WEST WINDSOR TOWNSHIP

MEMORANDUM

DATE: September 15, 2020

SUBJECT: **Heritage Village @ West Windsor**
Preliminary/Final Major Site Plan and Subdivision
Block 28, Lots 15 & 21
#2044 Old Trenton Road (CR 535) and Princeton-Hightstown Road (CR 571)
PB 19-08

Figure 1: Construction Phasing of Units

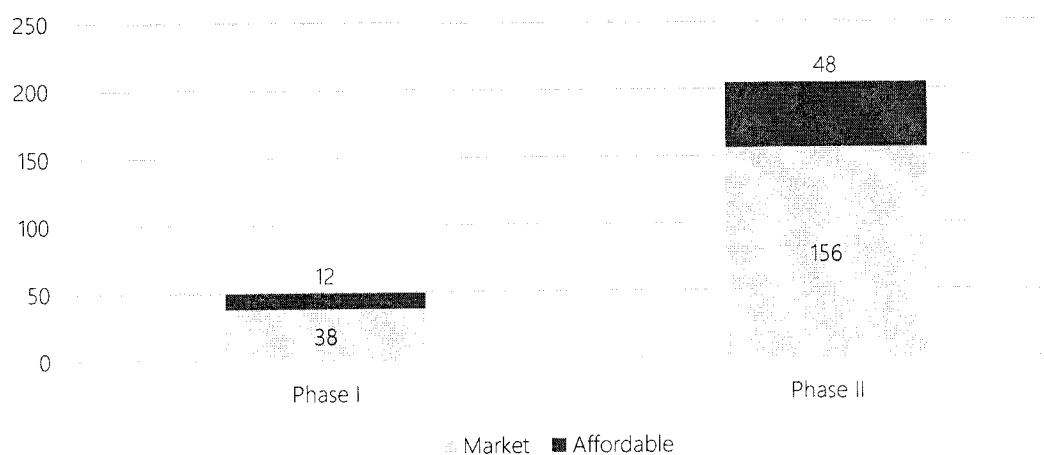
In consideration of the above, we note the following:

- c. The applicant should provide testimony as to the envisioned timeline of the proposed scheduling.
- d. The applicant should confirm compliance with NJSA 5:93-5.6, which establishes the following sequencing for the construction of affordable units:
